**DATE:** 06.26.2018  
**TO:** ProTrak  
**FROM:** Mitesh Baxi  
Traffic Engineering

■ **COLLECTION AT INDEPENDENCE PHASE 1 [TRC Plan Review]**

↻ Initial Review Note ↻

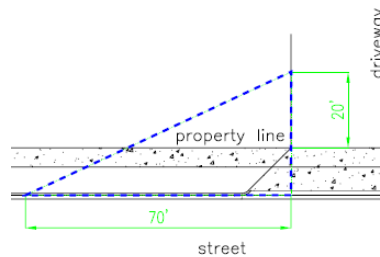
- Labels/location for key notes PA-6 and PA-7 are not found on the site plan. Please verify.
